# **DEVELOPMENT ASSESSMENT REPORT – DA020/19 - PROPOSED SUBDIVISION - 1 LOT INTO 4 and 4 DWELLINGS, LOT 6 DP 1250061, 7 CURA CLOSE LITHGOW NSW 2790**

To assess and recommend determination of DA020/19. The recommendation is for refusal.

**Figure 2: Site Plan and Lot Configuration a**

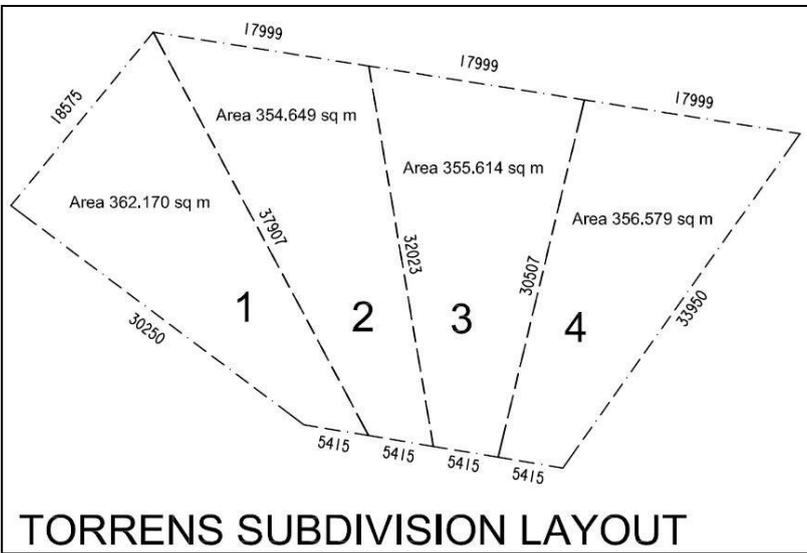
Each dwelling provides for an irregular shaped and unusable configuration of private open space area.

**Private Open Space:** Each dwelling provides for an irregular shaped and unusable configuration of private space area for each dwelling. None of the dwellings provide for usable open space areas, with the open space areas being 'left over' sections of land between the dwelling buildings. The open space areas do not provide for dimensions which are useable to accommodate outdoor recreational needs.

Dwelling 1 – Provides an alfresco (covered deck) area of 3.8m x 1.8m and a triangular yard area of 3m x 5m = 15m<sup>2</sup>.

Dwelling 2 – provides a wrap around alfresco (covered deck) area of 3.5m x 1.5m + 1.5m x 2.2m and piecemeal areas of yard on the southern side of the dwelling (triangular dimensions 2.8m x 5m and 2m x 3m)

Dwelling 3 – provides an alfresco (covered area) 2m x 3m and yard area (triangular dimensions 3m x 5m=15m<sup>2</sup>)

Dwelling 4 – provides an alfresco (covered area) 3m x 1.5m and yard area of 3m x 5m =15m<sup>2</sup> plus other piecemeal areas of yard along the eastern side boundary.

The proposal does not provide adequate and useable private open space.

**Figure 3: Subdivision Layout Plan**

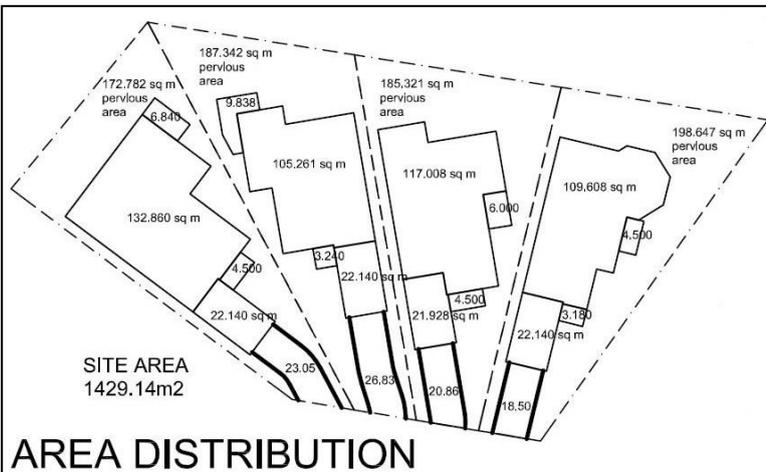
The proposed lots are considered to be irregular in size and configuration with long, north-south orientation. The lots contain an average frontage width of 5.4m, in comparison with the current lot width of approximately 21m. The proposed lot widths are likely to contribute to problems with the built form, the provision of private open space, privacy and solar access of the proposed dwellings.

In comparison to subdivision requirements set out in AMCORD (used as a guide only to assist in assessment) (Element 5.2 Lot Layout, page 153) provide for Lots with an area of between 300m<sup>2</sup> – 450m<sup>2</sup>, capable of containing a rectangle measuring 9m by 15m. The proposal does not meet this requirement and provides for splayed lots with narrow lot frontages, splaying to a wider rear area. This in turn affects the building configuration and is unable to achieve adequate private open space.

The proposal does not provide for an adequate lot configuration, size or width.

**Figure 4: Site Area and Distribution of Buildings and Hard Surfaces**

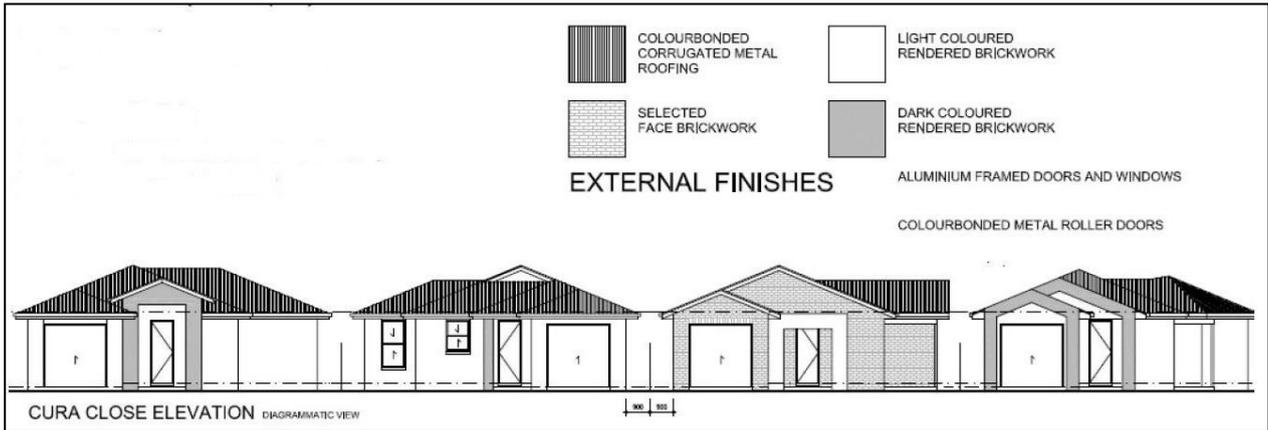
The total minimum area of open space required under AMCORD for each dwelling would range between 70-72m<sup>2</sup> per dwelling. While each lot provides a pervious area of between 172m<sup>2</sup> and 198m<sup>2</sup>, it does not meet the other provisions of dimension size, gradient and location off the

living area of the dwelling. A large proportion of this pervious area is contained within the drainage easements which is steeply sloping land and not considered to be an acceptable solution for open space provision.

**Figure 5: Elevation of Proposal from Cura Close**

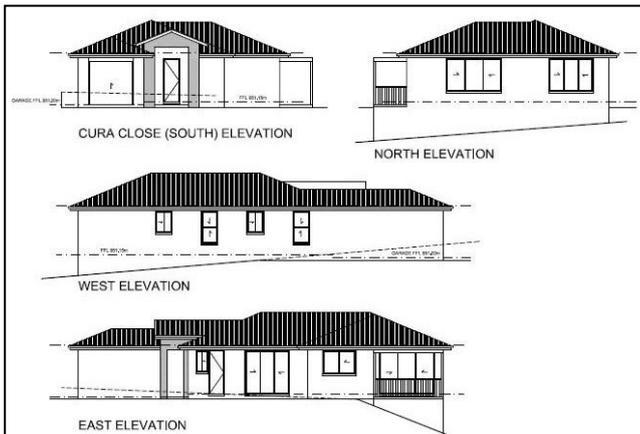
The applicant has failed in the design of the new dwellings to locate the garages on the site in an appropriate location. The proposed location is likely to diminish the attractiveness of the streetscape. The garages have been positioned to sit well in front of the proposed dwellings and will dominate views of the dwellings from the street. This design concept fails to address AMCORD requirements (see Element 5.3 Street Setbacks – Carports and Garages, page 158-159) (used as a guide only to assist in assessment) to ensure that garages do not dominate the street appearance. This in turn will reduce the opportunity for surveillance of the street from dwellings with restriction of views of the buildings from the street.

**Figure 15: Photo montage provided by applicant**

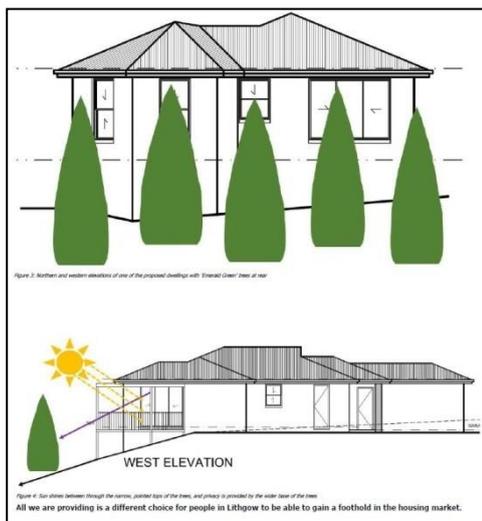
While the landscaping is likely to alleviate a small degree of privacy and overlooking to adjoining neighbours, there will still be a degree of privacy and overlooking from the dwellings

into the adjoining residential backyard areas (Short Street neighbours) due to the steep topography of the site. Concern is also raised in relation to the impact that the proposed landscaping will have on solar access to the proposed residential allotments. Due to the orientation of the allotments in a north –south orientation, the solar access to the open space areas and the living areas of each dwelling will be compromised.

The applicant has provided some sectional details and photo montage of how the landscape treatment will not affect the solar access to the dwelling. These diagrams have not been drawn to scale and therefore an assessment cannot be undertaken on this documentation and cannot be seen to be a true representation on how the proposed landscape treatment will affect solar access to the proposed dwellings.
